RIVER FOREST DEVELOPMENT REVIEW BOARD MEETING AGENDA

Subj: Lake and Lathrop Planned Development Application

Re: Planned Development Review
Revised Lake & Lathrop Mixed-Use Development

UPDATED ELEVATIONS TO SHOW STAIRS AND ELEVATOR OVERRUN ON ROOFTOP (8/20/2018)

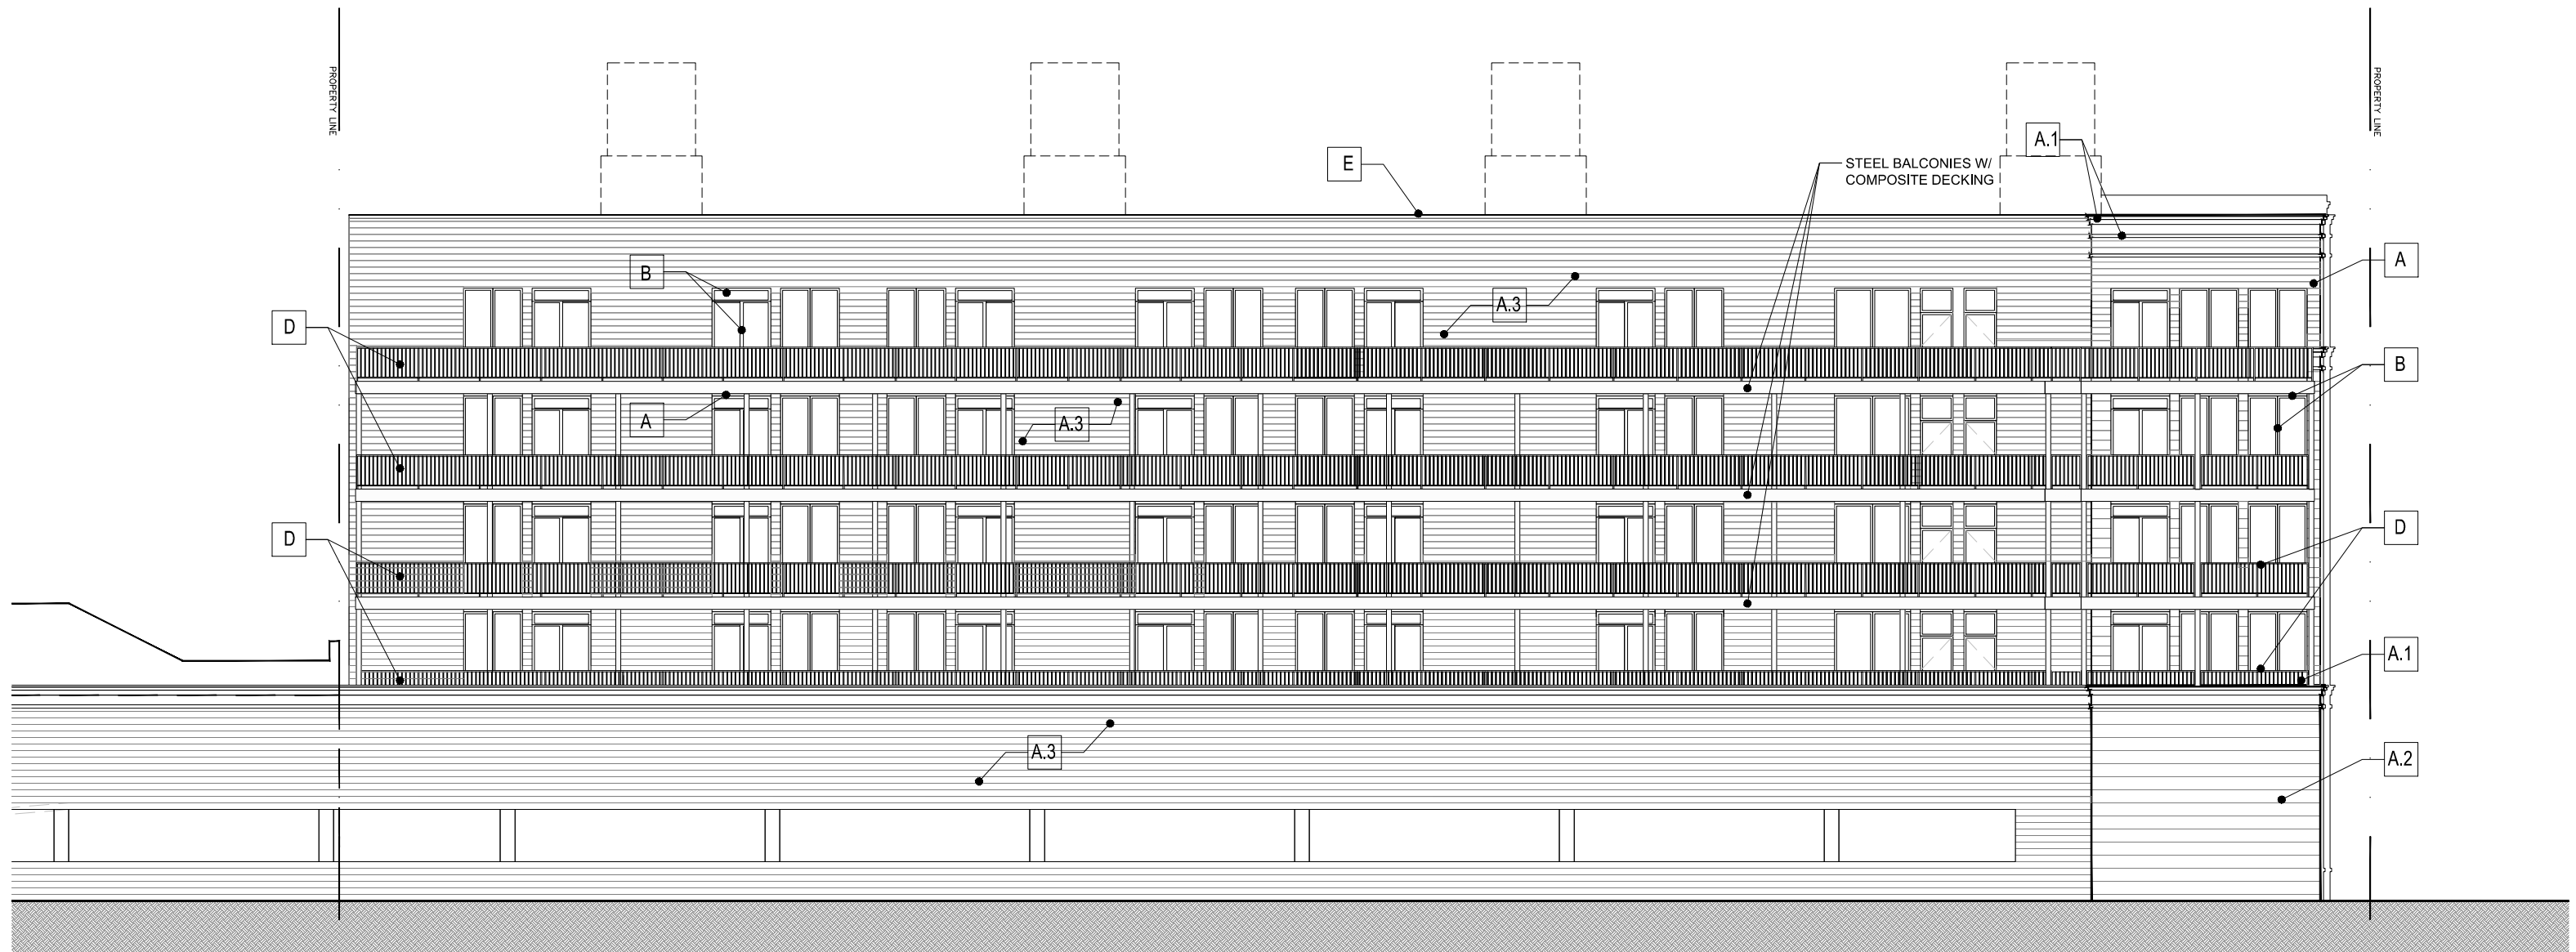
Although the height to the top of the parapet has been lowered 3', from 74' to 71', and the "high corner" has been reduced 7', from 80' to 73', the maximum height of the building has been increased from 80' to 85' to accurately accommodate the proposed stair and elevator overruns. These features are not located at the edge of the building and are therefore less visible than the parapet or exterior elevations of the building. However, these features (stair and elevator overruns) will be visible from certain ground floor perspective when approaching the building, as the features protrude 14' above the height of the parapet. Because River Forest measures the height of the building at its highest point, the proposed height for the development is 85' and will require a 35' SDA for height. The maximum height allowed in the C-3 District is 50'.
